## Exhibit 3

## RESPONSE TO COMMENTS

**Civil Action No. 1:16-cv-914**

## DECLARATION OF MARC LAMONTAGNE

**Figure 1. Just surviving crack for hydrostatic test of 2000 psi in NPS 20, Gr A, 0.812" WT****Figure 2. ITP estimate of fatigue life based on nominal pipe properties.**

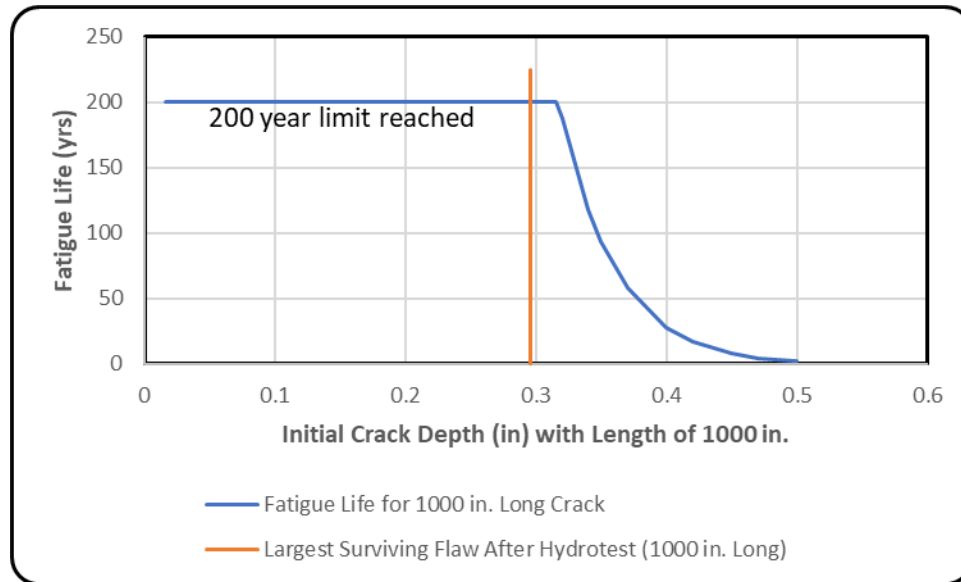
Kiefner Report estimates by using an alternative software to independently evaluate the remaining life of crack features that could have survived the 2017 hydrostatic test pressure. The remaining life estimates in the Kiefner Report and Mr. Lamontagne's analysis both substantially exceed the five-year remaining life period that would trigger excavation and repair requirements under the Consent Decree.<sup>10</sup> Mr. Lamontagne's analysis indicated that the Kiefner Report remaining life estimates are conservative, and he concurred with the conclusions of the Kiefner Report. *Id.*, at ¶ 22 and Figure 2.

23. During the creation of Figure 2 it was found that no fatigue crack growth under typical operating conditions was shown to occur by calculation until a crack depth of 0.315" is surpassed. This can be said to be primarily due to the low operating stress and heavy wall pipe. More on crack growth follows.

**Figure 3. CorLas Critical Crack Dimensions for the Dual Pipeline**

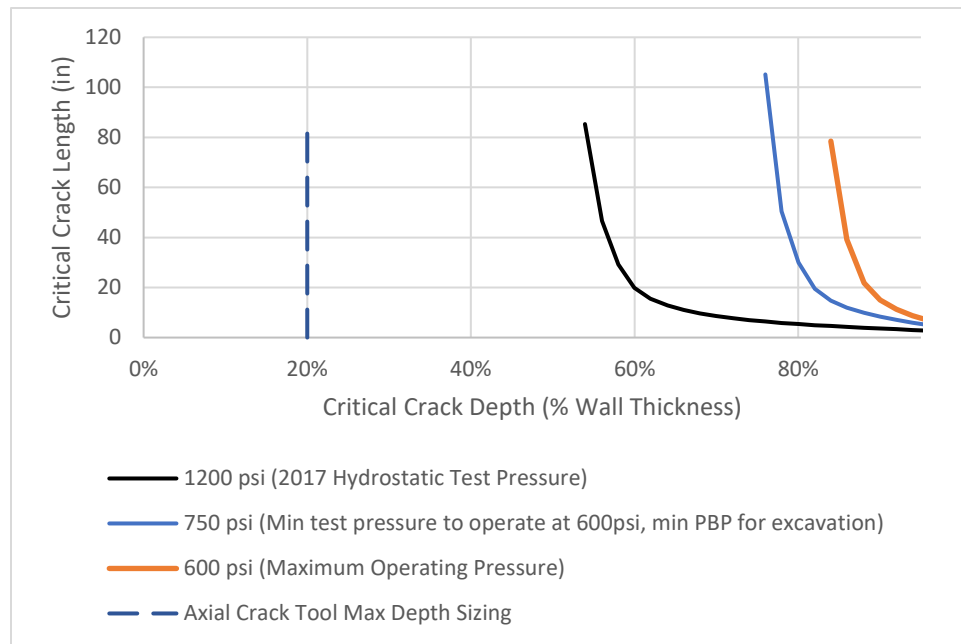
One commenter mistakenly interpreted the proposed Modification as suggesting that it is possible to differentiate among saturated signal features in a way that would allow Consent Decree requirements for repair or mitigation and pressure restrictions to exclude benign features and focus on an identified subset of saturated signal features that pose threats to pipeline integrity. Exhibit 2, Comment 7. That commenter questioned “the decision-making process for the proposed change to the Decree,” arguing that the government should not revise requirements relating to axial crack ILIs on the Dual Pipelines simply “because potential axial aligned features identified by an ILI could include features that do not pose a material threat to the integrity of the pipeline . . . [or] cause an unnecessary reduction in pipeline pressure.” Exhibit 2, Comment 7. This comment misapprehends the basis for the proposed modification of Paragraph 71 of the Consent Decree. As an initial matter, as discussed in Attachment 1, the Lamontagne Dec., at ¶ 27, ILI data regarding saturated signal features does *not* provide sufficient feature-specific depth information to support feature-specific risk determinations under the Consent Decree. For that reason, commenter’s suggestion that the Modification should be revised to mandate current axial crack ILIs on the Dual Pipelines but to limit application of dig selection criteria to exclude features that ILI data shows to be benign is not possible.<sup>13</sup> Second, contrary to the commenter’s assumption, the proposed modification of Paragraph 71 does not reflect a premise that the mere fact that an ILI results in repair or mitigation of benign features in itself provides a basis for suspending or eliminating use of particular types of ILIs. Rather, as discussed above, the conclusion that any saturated signal crack feature on the Dual Pipelines would not pose a risk of pipeline failure is based on an analysis of information developed from the 2017 hydrostatic pressure test. *Id.*, Figure 3.

29. I used the CorLas® software to examine critical crack dimensions at 600 psi (the MOP applicable to the Dual Pipelines), 750 psi (the minimum hydrostatic strength test pressure to operate at 600 psi and also the minimum PBP for excavation under the Consent Decree) and at 1200 psi (the peak pressure during the hydrostatic pressure test). The results of this analysis are shown in Figure 3. The black line in Figure 3 indicates the critical crack depths and lengths for failure at the hydrostatic pressure test pressure of 1200 psi. The orange line in Figure 3 indicates the critical crack depths and lengths for failure at the Maximum Operating Pressure of 600 psi. The solid blue line in Figure 3 shows the most stringent PBP-based dig selection criteria which are pegged to 1.25 x MOP. Therefore, any crack feature meeting Consent Decree criteria for excavation and repair would have failed during the hydrostatic pressure tests performed in 2017. Note the wide variance for the potential cracks being remedied by the 2017 hydrostatic test versus that which could be sized by a UC ILI. Note that in reference to Para. 24, Figure 3 only details the 4mm ILI tool depth sizing.

30. Based on the results of the ITP's CorLas® modeling, the ITP concludes that any crack feature that would have survived the 2017 hydrostatic pressure tests would not have met CD excavation and repair criteria. A conservative analysis employing nominal pipe properties has provided that crack feature surviving the 2017 hydrostatic pressure tests will have a greater than 200 year remaining life up to a depth of ~90% as illustrated by the yellow curve in Figure 4. The remaining life of any potential crack defect is well beyond the 5 year CD reinspection requirement.
